Norfolk Road Walking and Cycling Trail

Detailed Design Stage Safe System Audit Report

Prepared for Carterton District Council

REVISION 1 - FEBRUARY 2023

Figure 5.3-1 – Separation at 666 Norfolk Road (extract from concept design report)

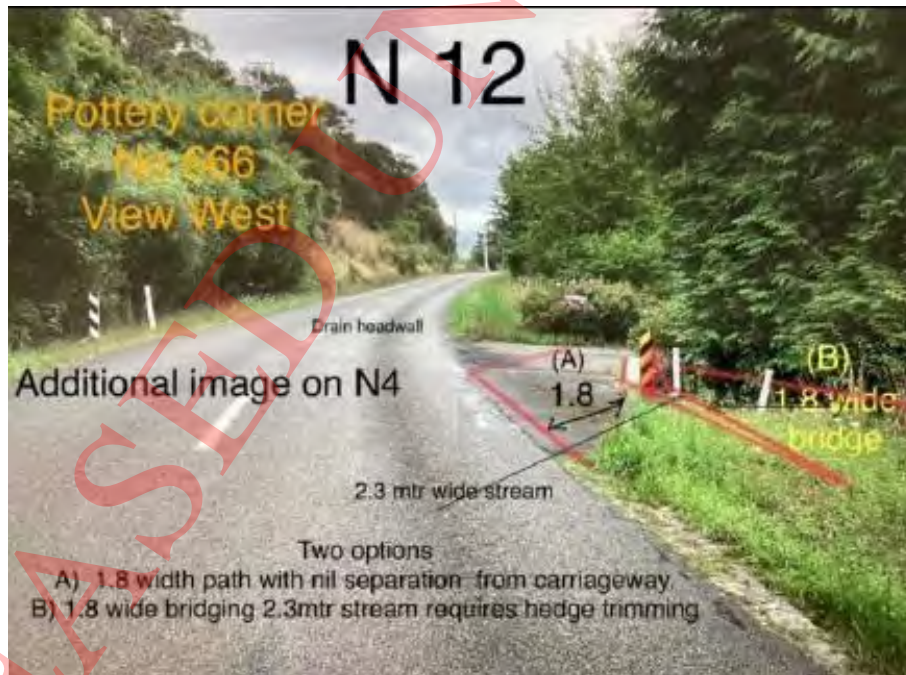
The designed path is proposed to be 2 m wide and with a 3 m separation from the road carriageway for most of its extension. However, in some locations, there are pinch points which reduce the separation distance, as follows:

- 605 – 606 Norfolk Road: 2 m separation;
- 666 Norfolk Road: nil separation (refer to Figure 5.3-1);
- 748 Norfolk Road: 0.5 m separation (refer to Figure 5.3-2);
- 889 Norfolk Road (Chester Road intersection): 1.5 m separation;
- Atiwhakatu single-lane bridge: on-road;
- Intersection corners at Maungahau Road and Parkers Road: unclear/unknown separation.

At these locations, trail users are closer to or on the road carriageway, therefore, being more susceptible to being hit by vehicles. This condition increases the probability of crashes involving these vulnerable road users at relatively high speeds, which could lead to a DSI. Note that the probability of crashes is still very unlikely at those points due to their typically short nature and low to moderate traffic and vulnerable road users volumes on these roads.

1. Provide kerb separators with safe-hit posts wherever the path is less or equal to 1.5 m from the road carriageway (example below);

2. Reduce the path width for short distances to accommodate the kerb separators with safe-hit posts if required (i.e., 666 Norfolk Road);
3. Consider boundary relocation to allow a uniform separation through the route;
4. Consider extending the existing culvert to accommodate the path at 666 Norfolk Road;
5. Provide warning signage (highlighting the presence of cyclists and/or pedestrians) at all pinch points, including the Atiwhakatu single-lane bridge.

Figure 5.3-7 – Overhung vegetation

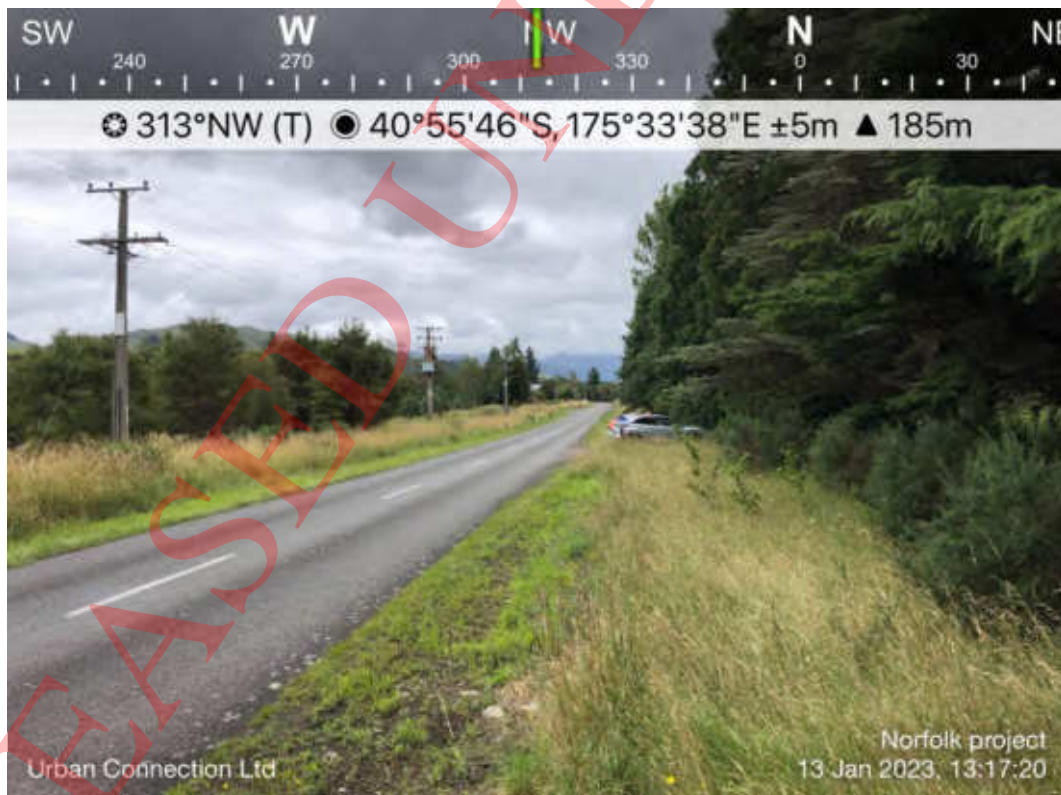
Some locations through the proposed project alignment have been identified to present hazards that can potentially injure trail users. These hazards are listed below:

- Drop-off hazard on Norfolk Road from approximately RP 6.045 to 6.300 (refer to Figure 5.3-5);
- Drop-off into the water hazards on culverts/water races at 570, 666, 855 Norfolk Road and 792 Chester Road (refer to Figure 5.3-6);
- Overhung vegetation for a significant portion of these roads (refer to Figure 5.3-7);
- Letterboxes throughout these roads that are within or immediately adjacent to the proposed path (refer to Figure 5.3-8). Particular regard has to be taken in relation to non-frangible and/or rigid letterboxes, for instance, as identified at 315 Norfolk Road (refer to Figure 5.3-9). These structures are a hazard not only for cyclists but for vehicles, increasing the severity of injuries in the case of an errant manoeuvre.

1. *Identify all locations/objects that present a hazard for trail users;*
2. *Provide cycle fence/rails to protect against the hazards;*
3. *Relocate letterboxes to suitable locations;*
4. *Remove and relocate rigid letterboxes, switching them to frangible-type letterboxes.*

Figure 5.3-10 – Treatment at intersections

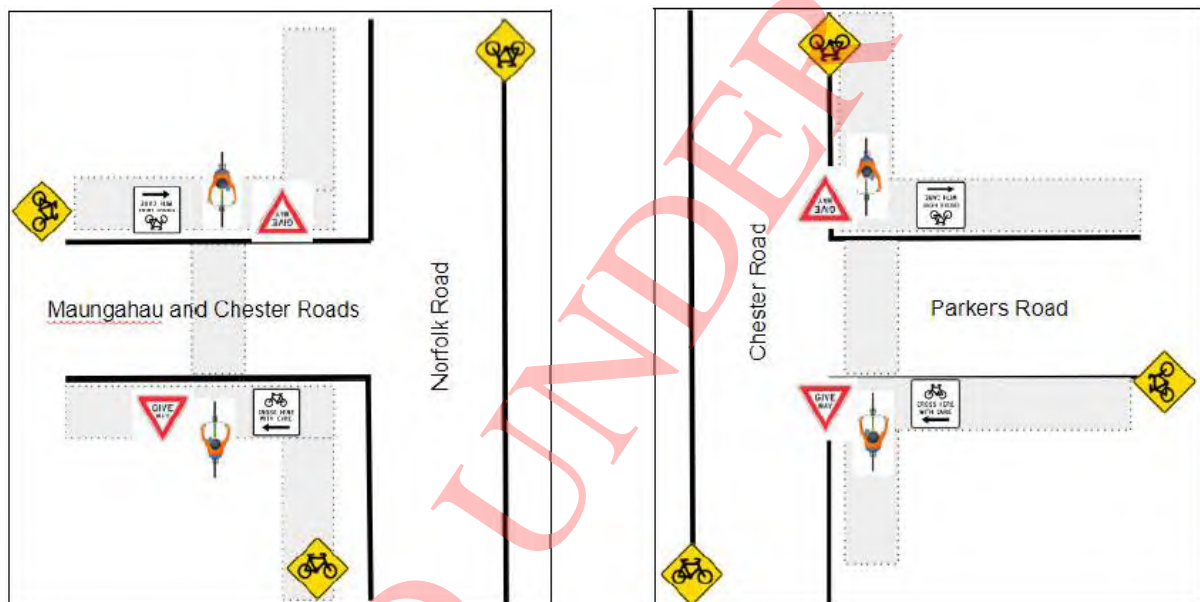
Some safety concerns have been identified in relation to the proposed layouts, as follows:

- The crossing layout on Maungahau and Chester Roads increases the travelled path for trail users through Norfolk Road, and, therefore, it is not considered the natural path (desire line) to be followed by users. Some cyclists/pedestrians could be expected to travel straight through the intersection to avoid the longer path on the side road. This could potentially generate conflicts with vehicles that would not be expected users at that point;

- The crossings on Maungahau and Chester Roads (20-30 m from Norfolk Road) result in restricted intervisibility between cyclists/pedestrians and vehicles turning from Norfolk Road. It is noted, however, that these vehicles would be expected to generally be turning out from Norfolk Road with relatively low speeds, which provides some form of mitigation;

- Conversely, at the Chester Road/Parkers Road intersection, the straight-through path crossing establishes the concern for path users shooting through the intersection, which currently has substandard visibility (as in Section 5.3.3);

- In the vicinity of the intersections, the trail could also be expected to have less separation from the carriageway, increasing the chances for errant turning vehicles encroaching over the path. It could also mean that errant cyclists could encroach onto the road while turning, especially in wet conditions. These conditions increase the probability of conflicts involving these users;

The considered ideal configuration for these crossings would consist of some horizontal deflection to slow down cyclists before the crossing points whilst not being far away from the main road to ensure good intervisibility between cyclists/pedestrians and vehicles. Kerb separators would also be ideally included through the horizontal deflections and where the path is closer to the road to delineate and separate the road and trail (Refer Section 5.3.2), preventing vehicles from tracking over it. It also would assist in delineating the path to be followed for cyclists, preventing them from going straight through the intersections.

1. Provide kerb separators (with safe-hit posts) to delineate the vicinity of the trail crossings;
2. Consider providing a short horizontal deflection, with crossings closer to the main road to ensure good intervisibility between road users;
3. Consider adopting raised safety platforms on path crossings to reduce vehicles speeds and highlight the crossing;
